SUSQUEHANNA STEAM ELECTRIC STATION
ANNUAL EFFLUENT & WASTE DISPOSAL REPORT
PLA-4596 FILE R41-2A

PENNSYLVANIA POWER & LIGHT COMPANY
SUSQUEHANNA STEAM ELECTRIC STATION
OFFSITE DOSE CALCULATION MANUAL

Revision 6

SUMMARY OF ODCM CHANGES

FIGURE 5
 ENVIRONMENTAL MONITORING LOCATIONS
 WITHIN ONE MILE OF THE SSES

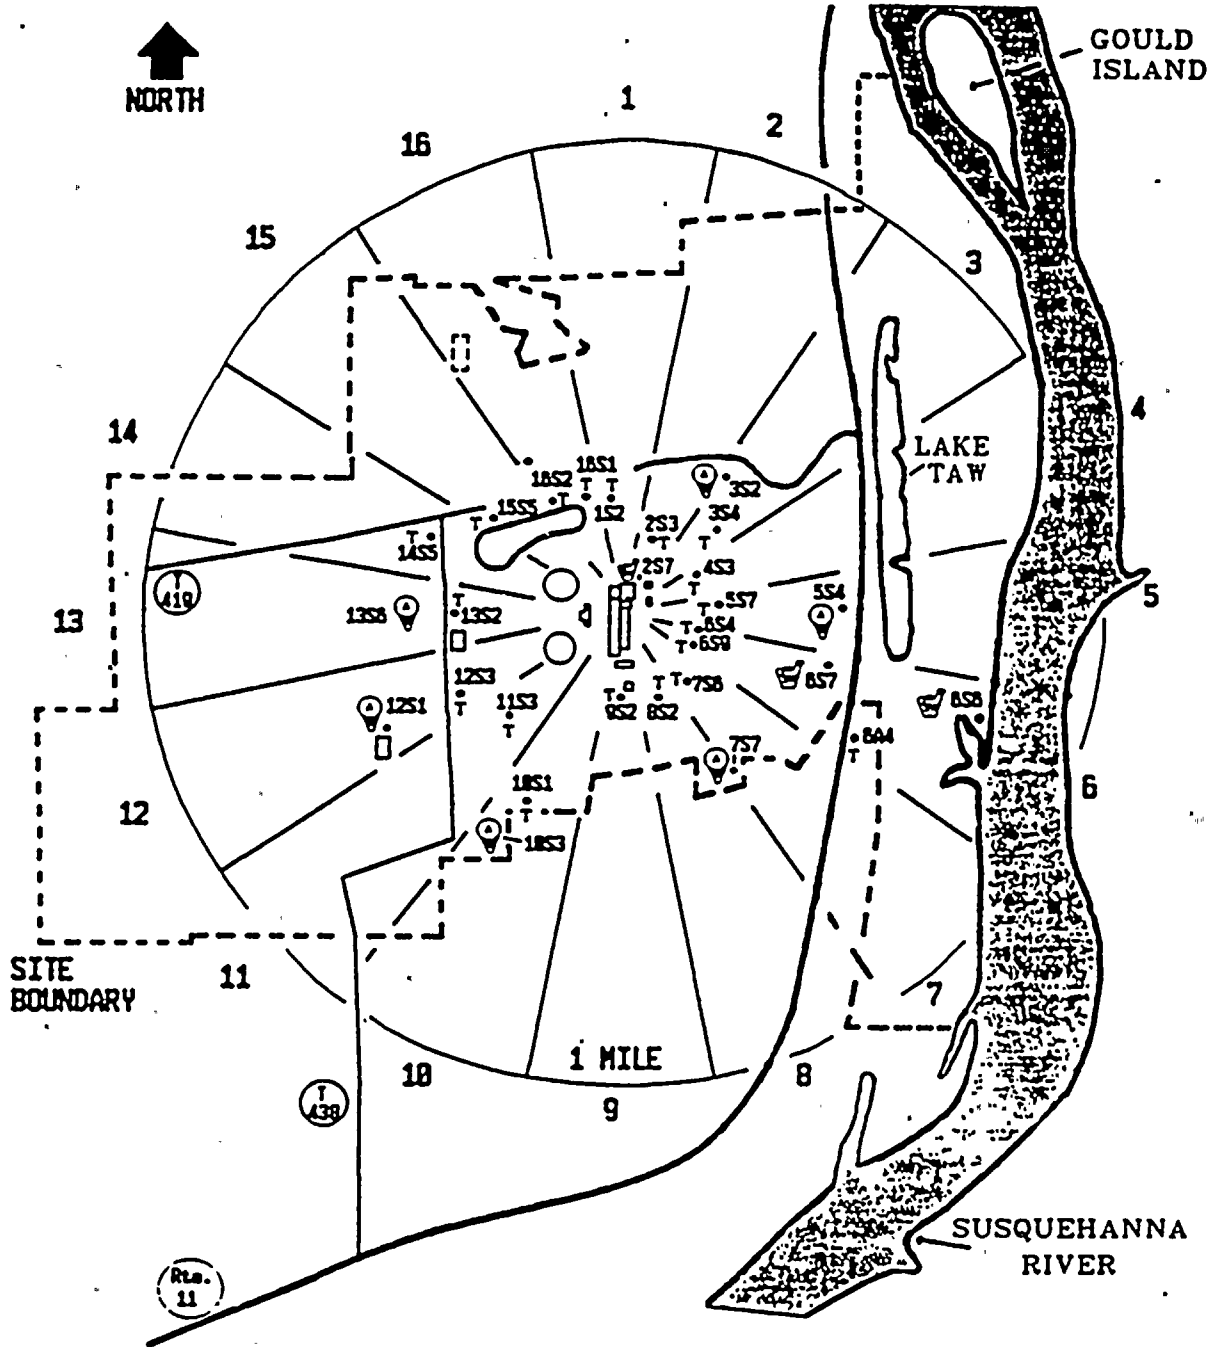
1. Maximum Dose Factor tables for Ru-103 and Te-129m have been added, in response to recommendation in CR 95-0743.
2. Water sampling location 2S7 has been added to Table 6 and Figure 5. This location was created to obtain a sampling environment that provides more representative samples.

FIGURE G
 ENVIRONMENTAL MONITORING LOCATIONS
 GREATER THAN ONE MILE FROM THE SSES

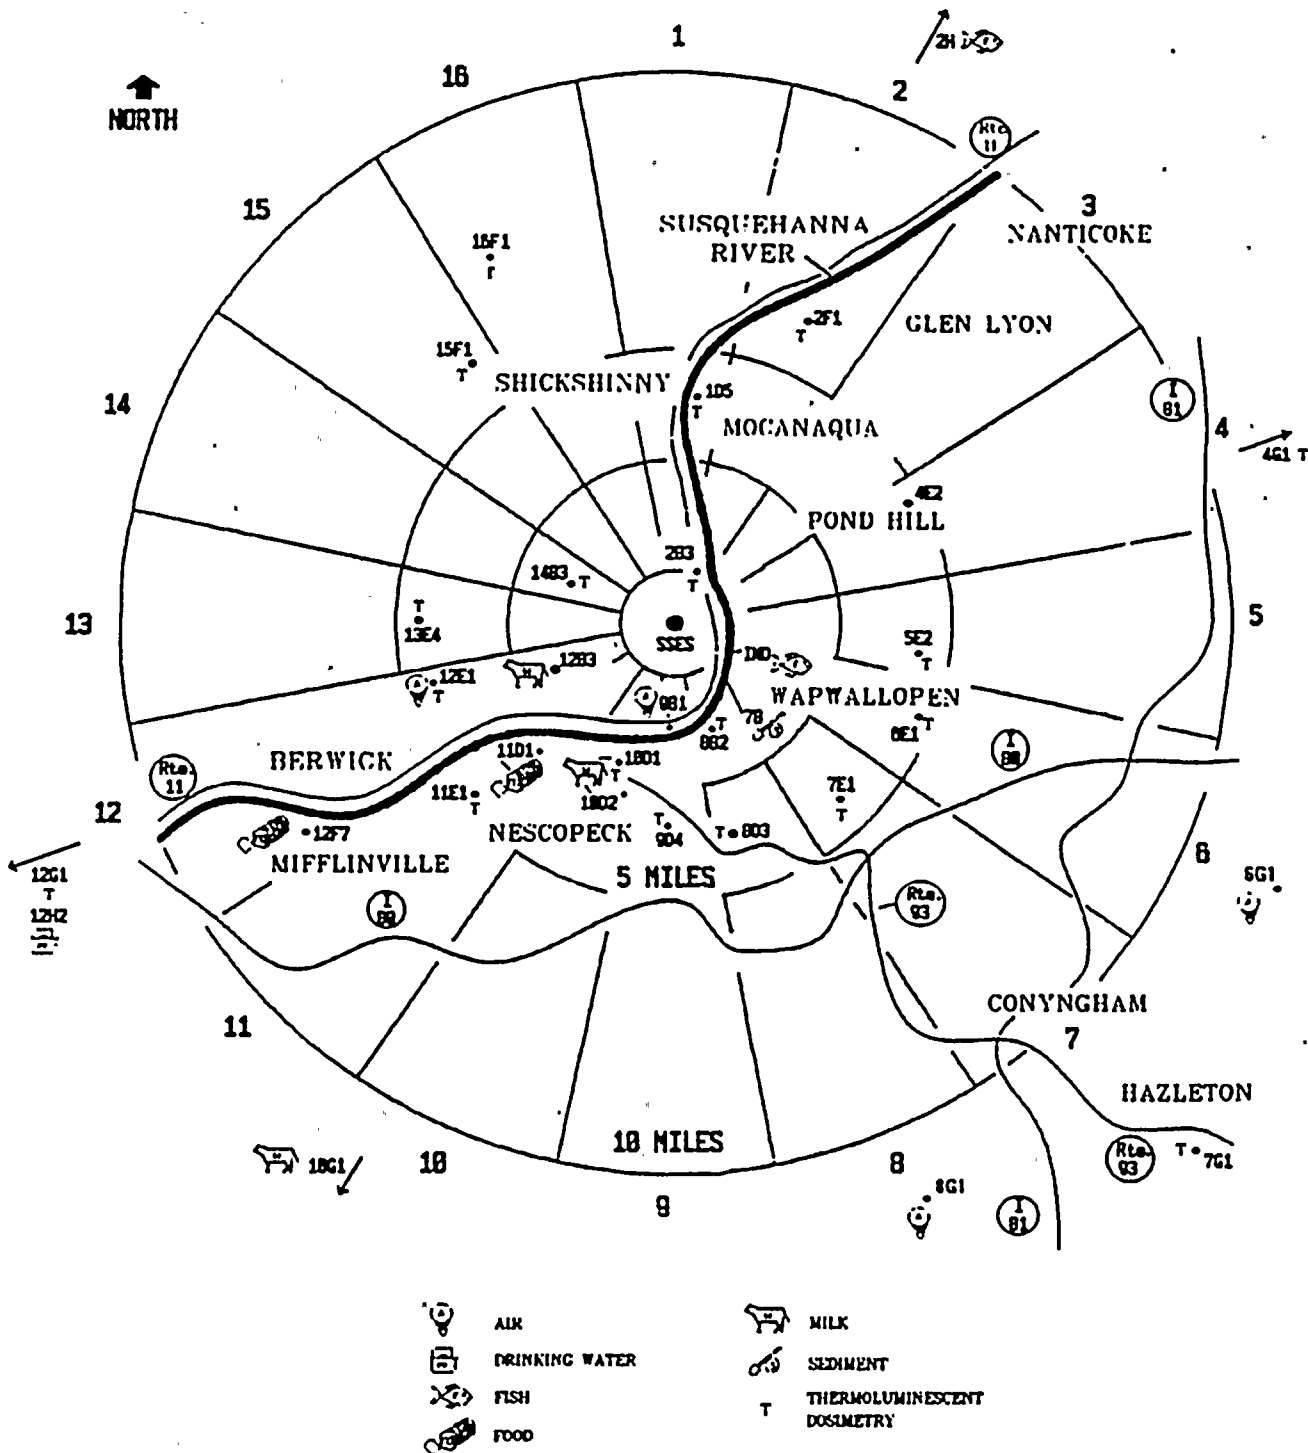
3. Air sampling location 6G1 has been added to Table 6 and Figure 6; location 12G1 is deleted from Table 6 and Figure 6. Location 12G1 was moved to location 6G1 to improve control characteristics of this site.

4. References to R (raw) and T (treated) deleted in Figure 6 for drinking water monitoring location 12H2. Only treated water is now collected at location 12H2.

5. Air sampling location 8G1 is added to Table 6 and Figure 6. Air sampling station 7G1 is deleted. This air sampling station was moved to location 8G1 to avoid the large trees that hindered the sampling efforts at location 7G1.
